# Access Compliance Report Public Rights-of-Way (RR Crossings)

Intersection ID: 10025367	Main Street: E_8TH_ST	Location: N/A
ADA ID: 13E8B578D41D	Overall Compliance: No	Severity Score: 0.0
Codes/Mitigation Info/Possible Solution		Field Measurements/Component Compliance

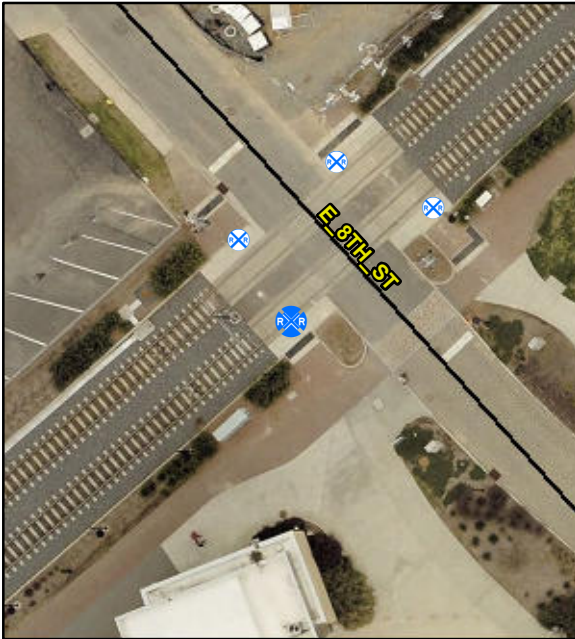
Compliance	Description	Data
Yes	DWS Provided?	Yes
Yes	DWS Contrast?	Yes
Yes	DWS Width (in)	Yes
Yes	DWS Length (in)	24.0
No	DWS Offset (in)	69.0
No	Pedestrian Gate?	No
N/A	DWS Outside Gate?	No
N/A	Rail Type?	N/A
N/A	Flangeway Gap (in)	3.0
Yes	Sidewalk Width (in)	109.0

**Remove & Replace Detectable  
Warning System. Provide Pedestrian  
Gate.**
